Response to Submissions

UTS City Campus, Broadway Precinct
GFA and Building Envelope Amendments

Submitted to Department of Planning and
Environment
On behalf of University of Technology Sydney

18 April 2019 | 218424

Figure 1 East-West Section as exhibited (left) and proposed (right), showing additional setback to Harris St and amended building height

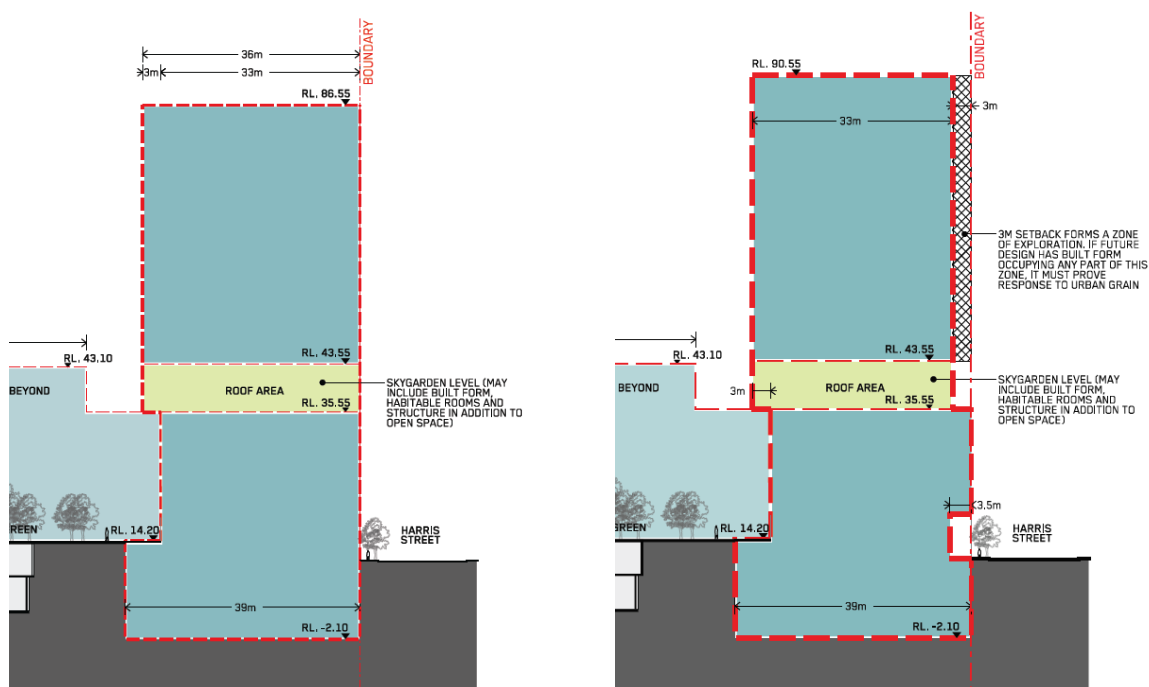
Following on from the submission by the City of Sydney, the DPE provided an analysis of the built form of Harris Street stating that there is a consistent street wall height of approximately 30m with any buildings taller than this height being setback from the elevation.

DPE requested the preparation of options exploring alternative setbacks along Harris Street above the parapet of the Bon Marche building. Each option is to be accompanied by appropriate visual analysis to determine the extent of the impact when viewed from the surrounding public domain.

Due to concerns raised by the City of Sydney and DPE in relation to the heritage significance of the Bon Marche building, pedestrian circulation around the site and the amenity of Harris Street, it is proposed to increase setbacks to Harris Street including:

- 3.5m at ground level (refer to further discussion in **Section 2.4**); and
- 3m above podium.

Refer to **Figure 1** below.

Informing the 3m above podium setback to Harris Street was a study undertaken by BVN of different setback options, 0m, 3m and 6m (refer to **Appendix K**) along with Council's recommendation for a minimum 3m setback.

Figure 2 North South Section as exhibited (top) and proposed (bottom), showing cantilever to be removed
Source: BVN

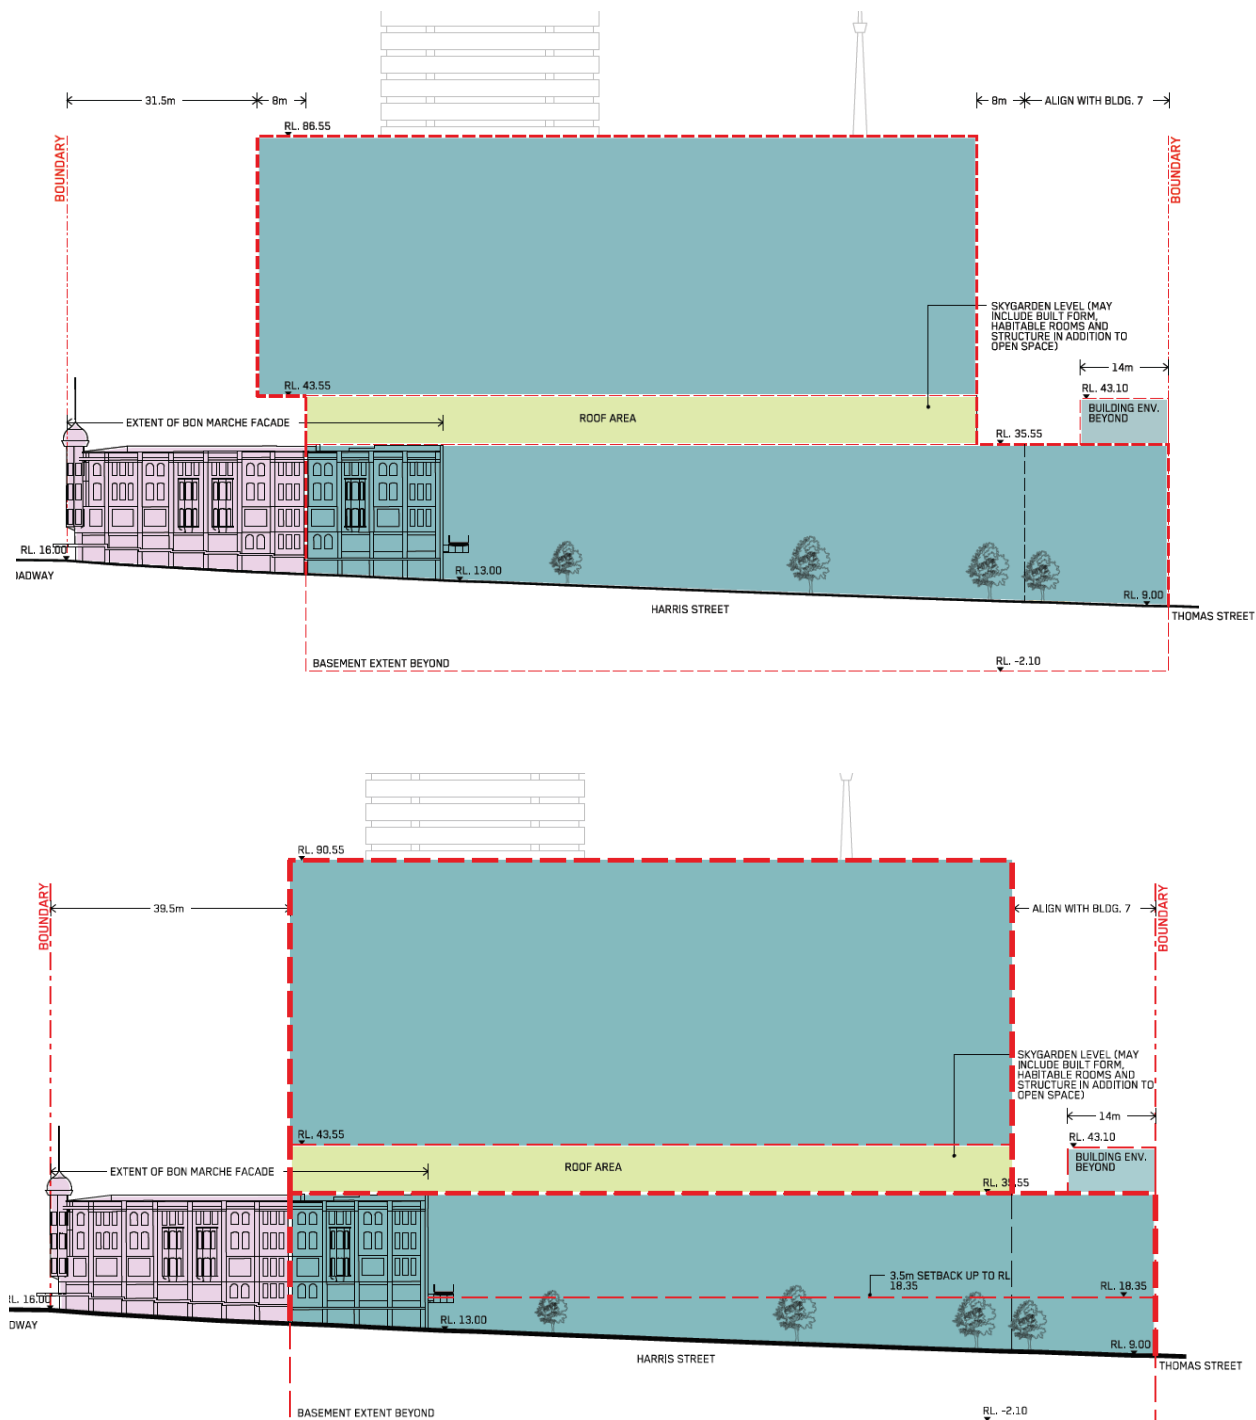
The City of Sydney and DPE have both raised concerns over the proposed cantilever over the existing two storey Apothecary building. The existing courtyard is proposed to be enclosed on all sides and the provision of a cantilevered building element further reduces the amenity of this space.

The DPE requests the proposed cantilever over the Apothecary building be removed.

Due to concerns raised by the City of Sydney and DPE regarding overshadowing and heritage issues, the proposed cantilever over the Apothecary building has been removed. Refer to **Figure 2** below and revised envelope drawings included at **Appendix B**.

Figure 3 Existing and proposed solar access impact on 16-18 Broadway

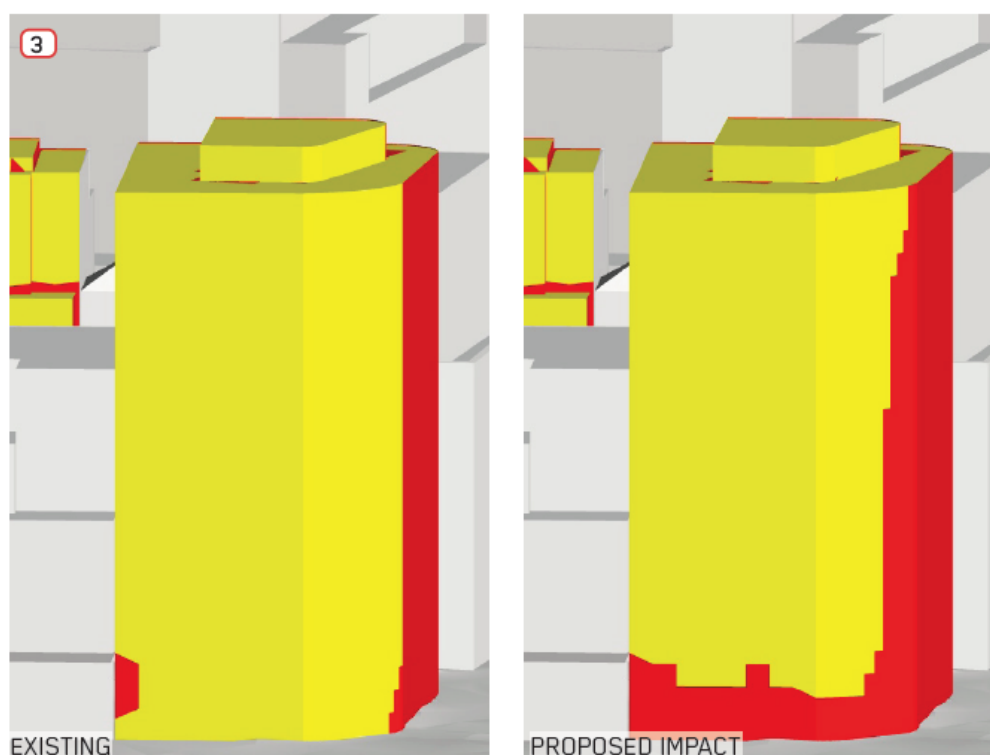
The DPE has noted the City of Sydney's comments regarding the potential overshadowing impacts on 16-18 Broadway. Given the extent of the proposed building envelope, the DPE is unlikely to support such a significant impact on the amenity of adjoining residential dwellings. The DPE requests further solar access analysis or building envelope amendments to ensure adequate levels of solar access is achieved for adjoining residential development.

Adjustments to the envelope have been made. A revised solar analysis of the amended envelope including with analysis of the impact on neighbouring multi-residential buildings is included within the Design Report at **Appendix B**.

The degree of change between what was existing and the impacts of the proposed amended building envelope are shown in Error! Reference source not found. below, with yellow representing complying surfaces (≥ 2 hours solar access) and red representing non-complying surfaces (≤ 2 hours solar access). The amended envelope results in an improved outcome for 16 – 18 Broadway, with additional shadows primarily falling onto the ground floor (retail).

Figure 9 Existing design: Pedestrian wind speed measurement location with comfort ratings

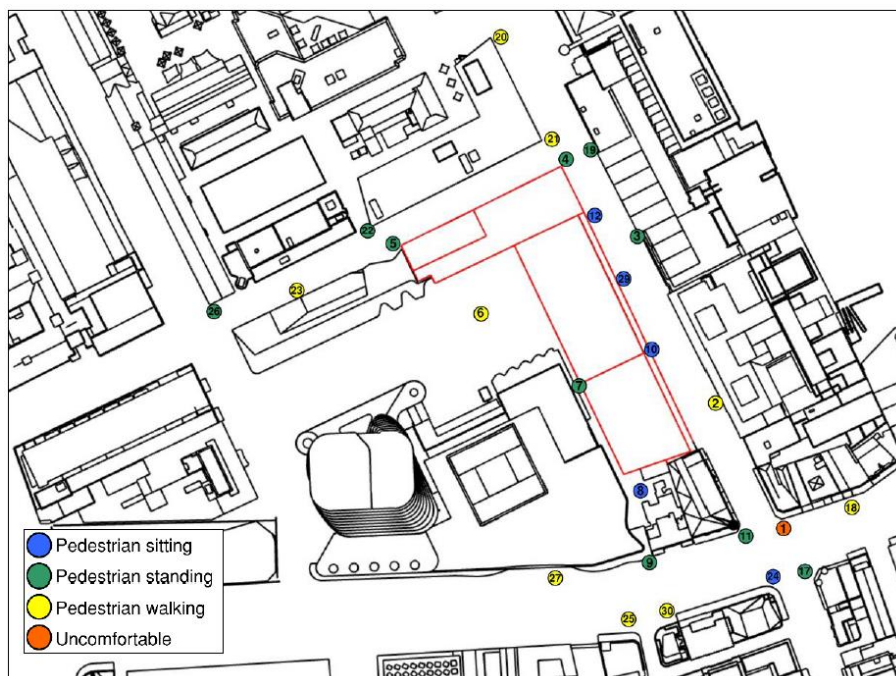
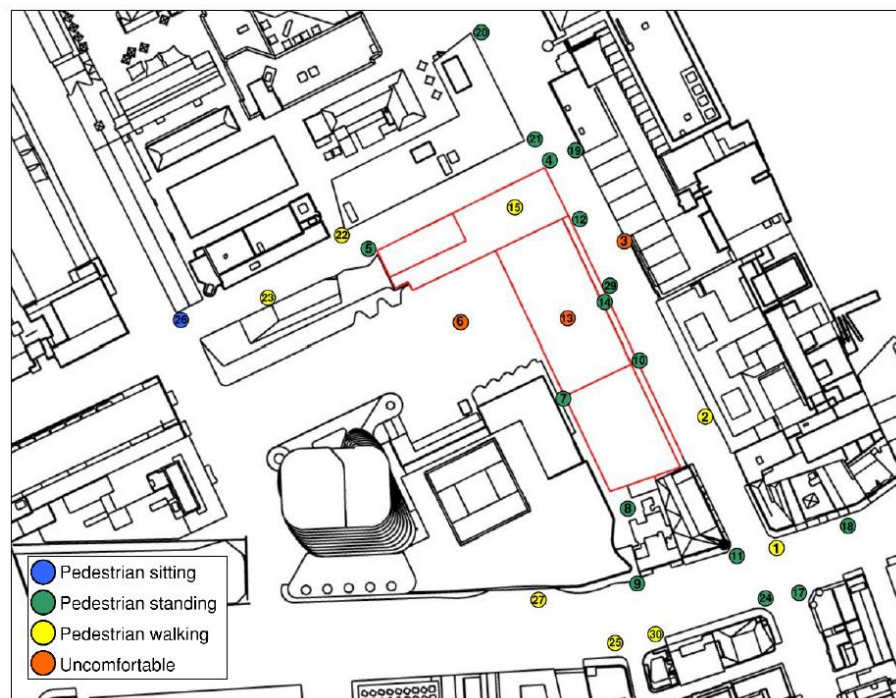
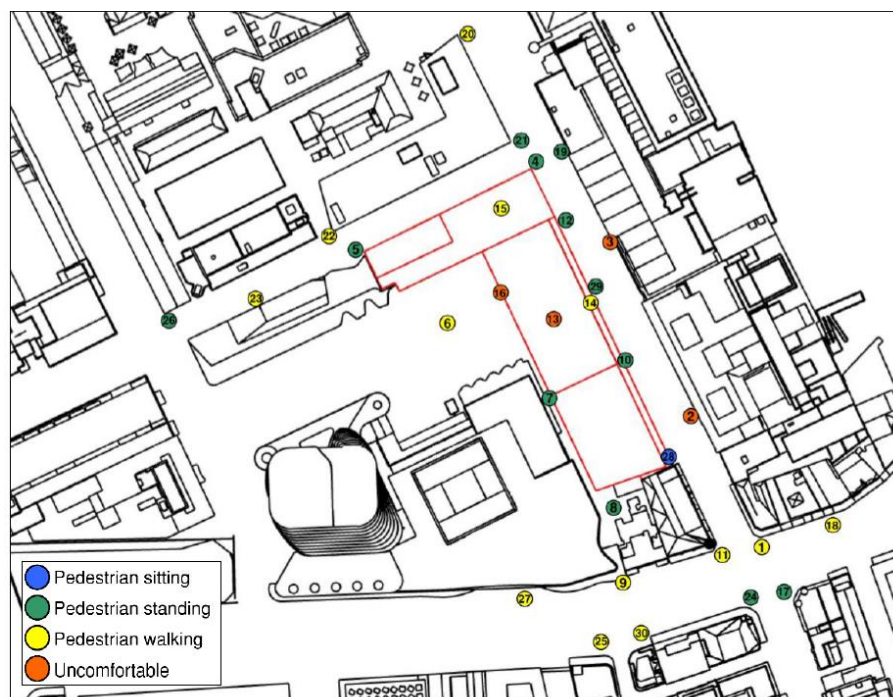
The DPE requires further consideration and details to be able to assess wind impacts of the proposed envelopes, including wind tunnel testing and using more localised wind data.

An updated Environmental Wind Assessment has been prepared by Arup and is available at **Appendix I**. The report includes analysis on wind tunnel testing, which was required to be undertaken as a result of DPE's comments as discussed in **Section 2.3**. The testing was conducted in three configurations: existing (see results at **Figure 9**), proposed control envelope (see results at **Figure 10**) and potential articulated scheme (see results at **Figure 11**).

The testing showed that for the proposed and articulated designs the wind conditions at most locations are similarly classified. The east side of Harris Street meets the non-active frontage walking criteria for all wind directions except one direction from the west. For the articulated scheme, measured wind speeds at this location are lower than the proposed envelope, suggesting that the porous podium roof assists with mitigating wind conditions at this location. Location 2 in the articulated scheme and Location 6 in the proposed control envelope would have wind conditions at the boundary of walking criteria which would be similar to Location 1 in the existing design.

The measured wind conditions were generally found to be similar to the existing conditions with a few locations on the border of the non-active frontage criterion. The added massing changes the flow pattern around the site, resulting in some locations becoming more windy, and others calmer. It is considered that wind conditions generated by the general massing of the development would produce an environment suitable for the intended use of the space. It is evident that changes to the proposed control massing scheme would slightly affect the local wind climate and testing of the final architectural scheme would be recommended. All locations in and around the proposed development would pass the safety criterion.
